CNL-15-128

Sequoyah Nuclear Plant, Units 1 and 2
Facility Operating License Nos. DPR-77 and DPR-79
NRC Docket Nos. 50-327 and 50-328

Subject: **Sequoyah Nuclear Plants, Units 1 and 2 Technical Specifications
Conversion to NUREG-1431, Rev. 4.0 (SQN-TS-11-10) - Supplement 2**

**Sequoyah Nuclear Plant, Units 1 and 2 Technical Specifications Conversion to
NUREG-1431, Rev. 4.0 (SQN-TS-11-10) - Revision 1**

Figure 2.1-1 Reactor Core Safety Limit - Four Loops in Operation

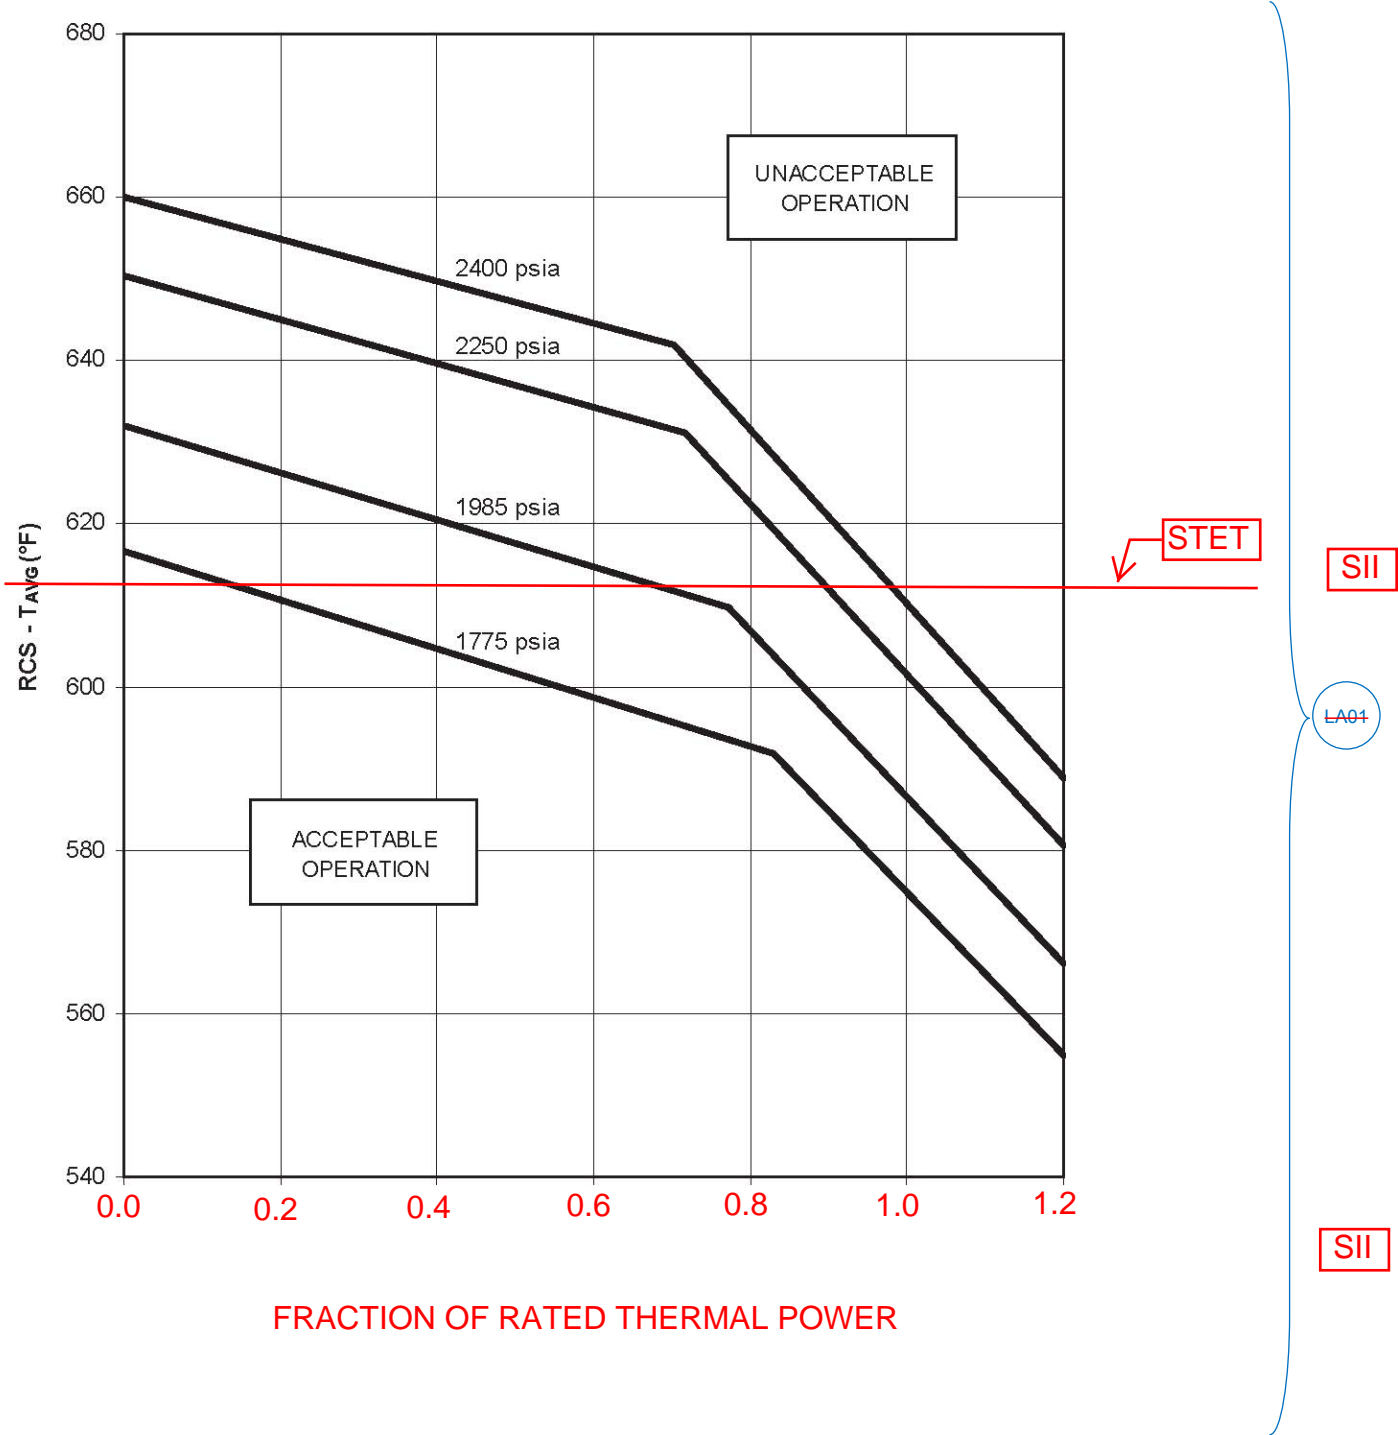
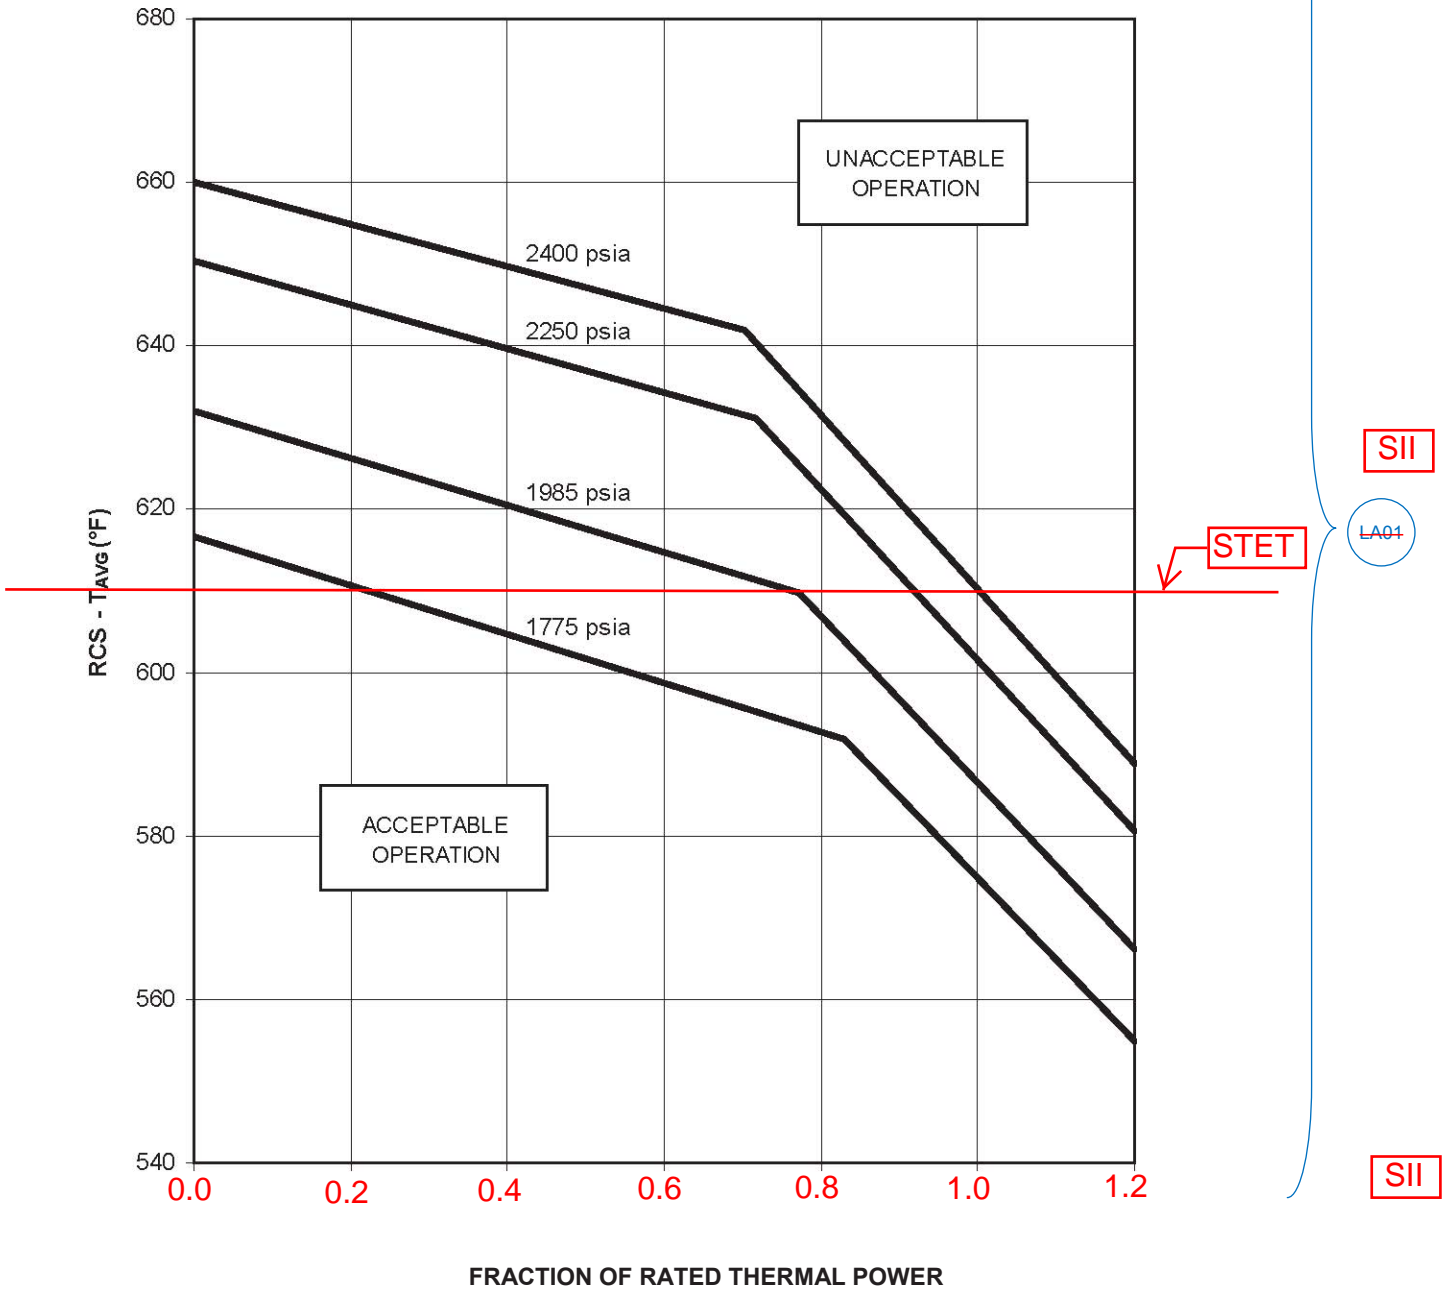
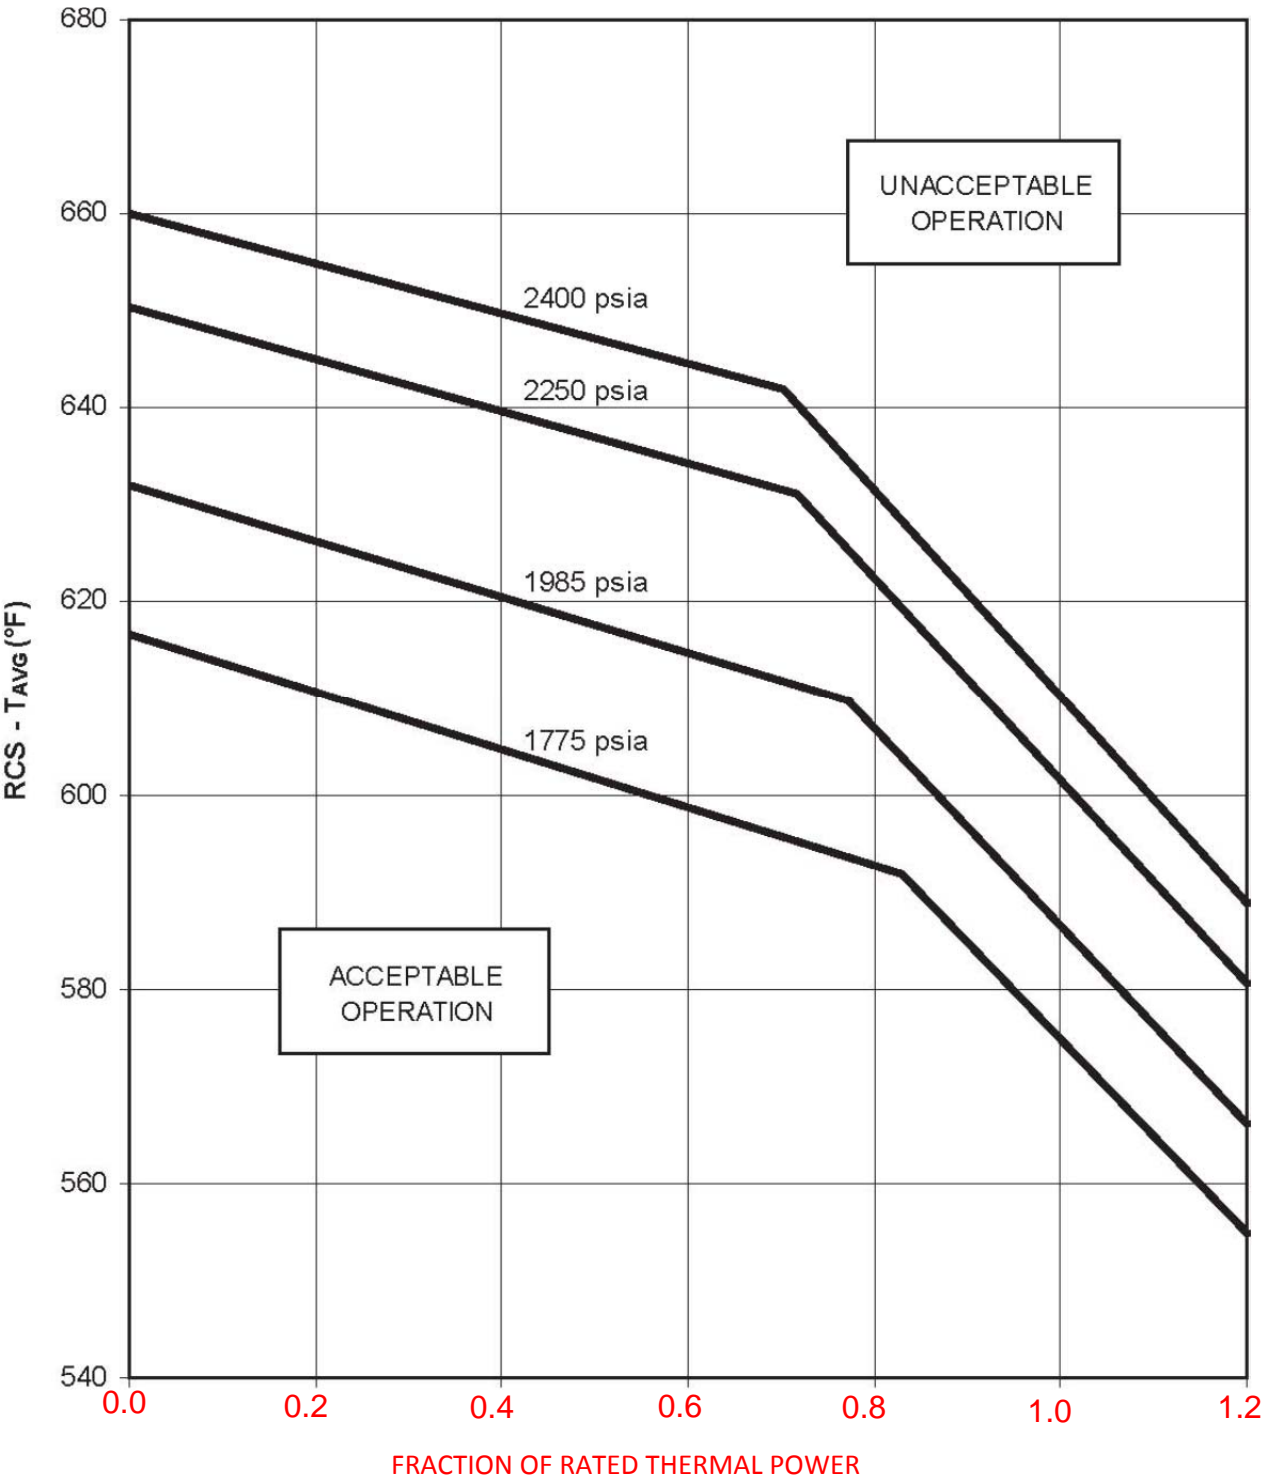
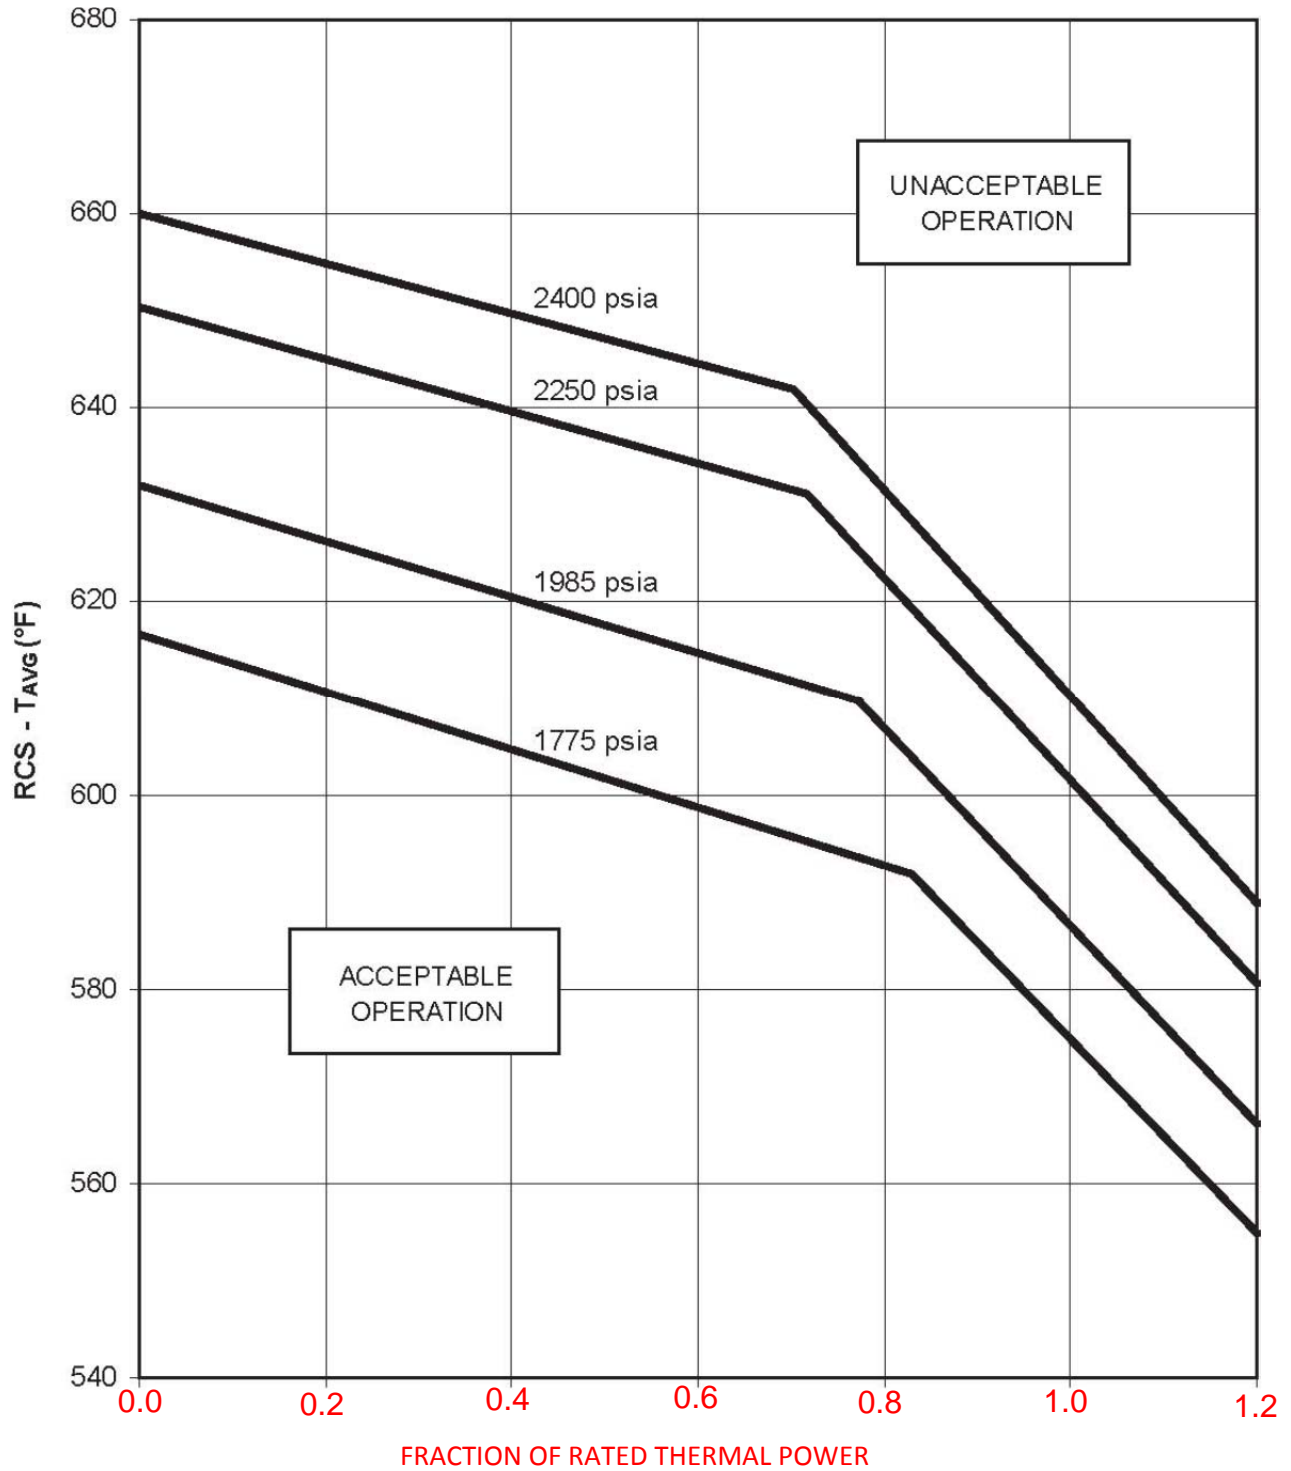
2.1.1 The combination of THERMAL POWER, pressurizer pressure, and the highest operating loop coolant temperature (Tavg) shall not exceed the limits ~~shown in Figure 2.1-1~~ and the following SLs shall not be exceeded:

2.1.1 The combination of THERMAL POWER, pressurizer pressure, and the highest operating loop coolant temperature (T_{avg}) shall not exceed the limits ~~shown in Figure 2.1-1~~ and the following SLs shall not be exceeded:

- LA01 ~~(Type 6 Removal of Cycle Specific Limits from the Technical Specifications to the Core Operating Limits Report) CTS 2.1.1 requires the combination of THERMAL POWER, pressurizer pressure, and the highest operating loop coolant temperature (T_{avg}) not to exceed the limits shown in Figure 2.1-1. ITS 2.1.1 states the combination of THERMAL POWER, Reactor Coolant System (RCS) highest loop average temperature, and pressurizer pressure shall not exceed the limits specified in the COLR. This changes the CTS by moving limits that must be confirmed on a cycle specific bases to the COLR. The Reactor Core safety limits are retained in Technical Specification Chapter 2.0.~~

This page deleted.

Figure 3.1.3 - 1 (page 1 of 1)
Moderator Temperature Coefficient Vs. Rated Thermal Power

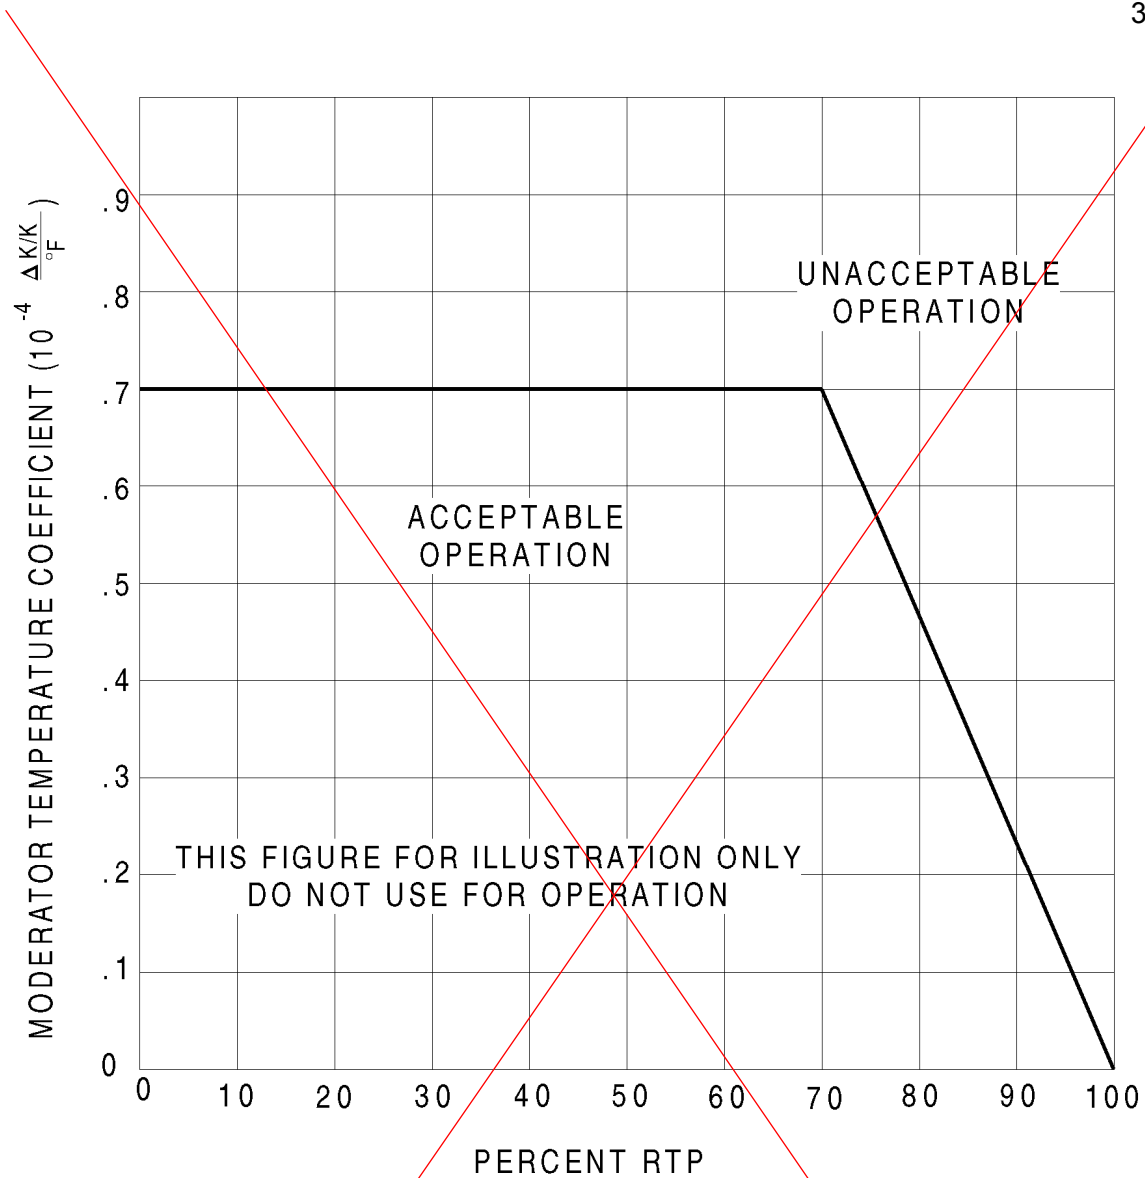
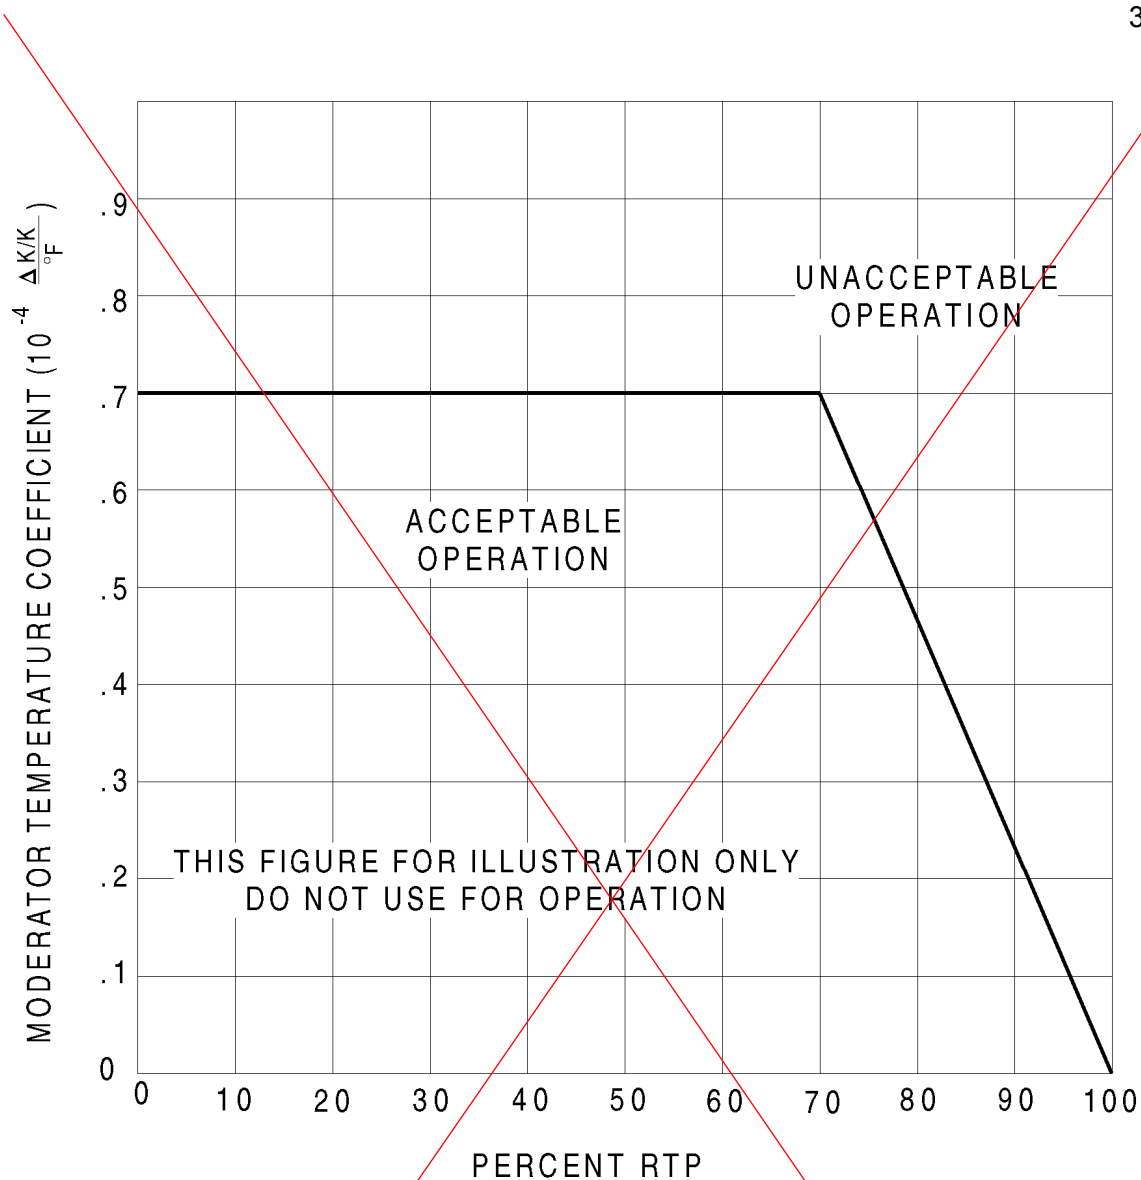
3.1.1.3 LCO 3.1.3 The MTC shall be maintained within the limits specified in the COLR. The maximum upper limit shall be $\leq [-] \Delta k/k^{\circ}F$ ~~at hot zero power~~ ~~[that specified in Figure 3.1.3-1]~~. < 0

1. The ISTS contains bracketed information and/or values that are generic to Westinghouse vintage plants. The brackets are removed and the proper plant specific information/value is inserted to reflect the current licensing basis.
2. Changes are made (additions, deletions, and/or changes) to the ISTS that reflect the plant specific nomenclature, number, reference, system description, analysis, or licensing basis description.
3. ISTS 3.1.3 contains Figure 3.1.3-1 for Moderator Temperature Coefficient Vs Rated Thermal Power. This figure is not maintained in ITS 3.1.3. ITS 3.1.3 lists the maximum upper limit value in the LCO. Therefore, ISTS Figure 3.1.3-1 is not required and has been deleted.
